## PIC16C63 Rev. A Silicon Errata Sheet

The PIC16C63 (Rev. A) parts you have received conform functionally to the Device Data Sheet (DS30234D), except for the anomalies described below.

**FIGURE 1: SCK PULSE VARIATION USING TIMER2/2**

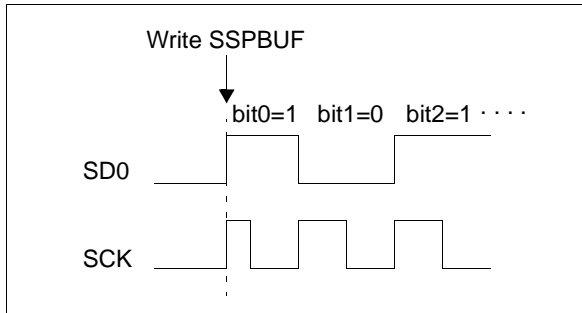
When the SPI is using Timer2/2 as the clock source, a shorter than expected SCK pulse may occur on the first bit of the transmitted/received data (Figure 1).

To avoid producing the short pulse, turn off Timer2 and clear the TMR2 register, load the SSPBUF with the data to transmit, and then turn Timer2 back on. Refer to Example 1 for sample code.

**FIGURE 1: WRITES TO TIMER1 (EXTERNAL CLOCK/OSCILLATOR MODE)**

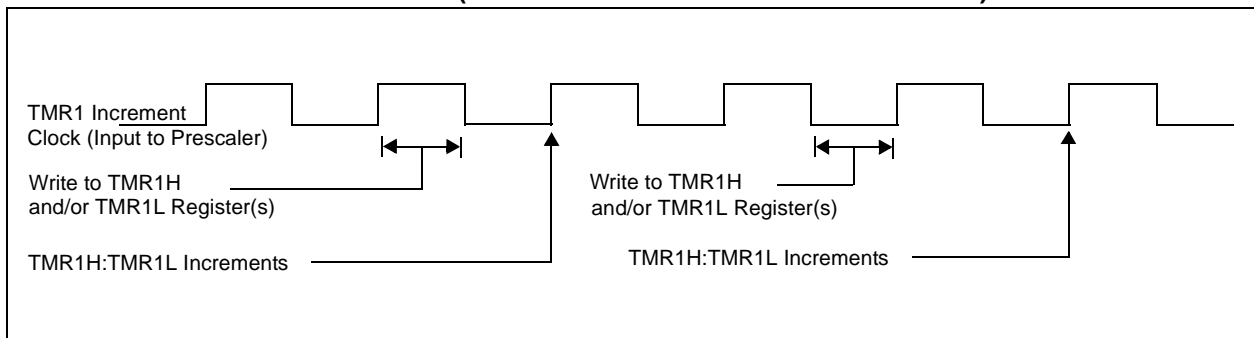
The operation of Timer1 needs some clarification when the timer registers are written when the TMR1ON bit is set.

The internal clock signal that is the input to the TMR1 prescaler affects the incrementing of Timer1 (TMR1H:TMR1L registers and the Timer1 prescaler). When the Timer1 registers are NOT written, the Timer1 will increment on the rising edge of the TMR1 increment clock.

When the TMR1H and/or TMR1L registers are written while this clock is high, TMR1 will increment on the next rising edge of this clock.

When the TMR1H and/or TMR1L registers are written while this clock is low, TMR1 will not increment on the next rising edge of this clock, but must first have a falling clock and the rising clock for TMR1 to increment.

Figure 1 shows the two cases of writes to the TMR1H and/or TMR1L registers. Due to the  $V_{IH}$  and  $V_{IL}$  thresholds on the oscillator/clock pins, external Timer1 oscillator components, and external clock frequency, the Timer1 increment clock may not be of a 50% duty cycle.

The TMR1 increment clock is out of phase of the T1OSO/T1CKI pin by a small propagation delay.
